UNITED STATES PATENT AND TRADEMARK OFFICE

APPLICATION NO.	FILING DATE	FIRST NAMED INVENTOR	ATTORNEY DOCKET NO.	CONFIRMATION NO.
10/579,852	05/17/2006	Dietmar Van Der Linden	R.307220	8908
2119 7590 05/22/2009 RONALD E. GREIGG GREIGG & GREIGG P.L.L.C. 1423 POWHATAN STREET, UNIT ONE ALEXANDRIA, VA 22314				
EXAMINER MCALISTER, WILLIAM M				
ART UNIT		PAPER NUMBER		
3753				
MAIL DATE		DELIVERY MODE		
05/22/2009		PAPER

Office Action Summary

DETAILED ACTION

Fig. 5

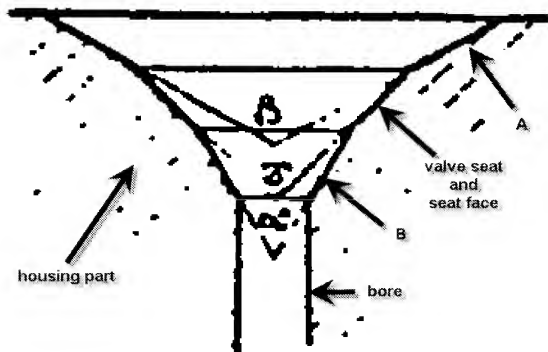
Regarding claims 8 and 10, Citroën discloses, in a valve for a high-pressure pump of a fuel injection system for an internal combustion engine (intended use met by Citroën's capability of being so used), the valve having a valve member (the "movable organ", as translated) which cooperates with a valve seat (see annotated close-up of FIG 5 below, in light of p. 1, ¶¶3 of the translation) formed in a housing part (see annotated FIG 5) on which seat the valve member rests when the valve is closed (inherently; it's a valve seat) in order to close a bore through the housing part (see annotated FIG 5), the valve seat having an at least approximately conical seat face which is located at a transition of the bore from a portion of small diameter to a portion of large diameter, the seat face forming an acute angle with the longitudinal axis of the bore (as understood), the improvement:

wherein the seat face, on its side oriented toward the portion of large diameter, is adjoined by at least one face ("A" of annotated FIG 5) which forms a larger acute angle with the longitudinal axis of the bore than the seat face (as understood), and

wherein the seat face, on its side oriented toward the portion of small diameter, is adjoined by at least one face ("B" of annotated FIG 5) which forms a smaller acute angle with the longitudinal axis of the bore than the seat face (as understood).

Citroën does not disclose an additional face which forms the largest acute angle, or an additional face which forms the smallest acute angle with the axis of the bore (as understood). However, it would have been obvious to one of ordinary skill in the art at the time of invention to provide two additional inclined faces, since mere duplication of the essential working parts of a device (i.e., adding more inclined faces) is generally seen as involving only routine skill in the art.
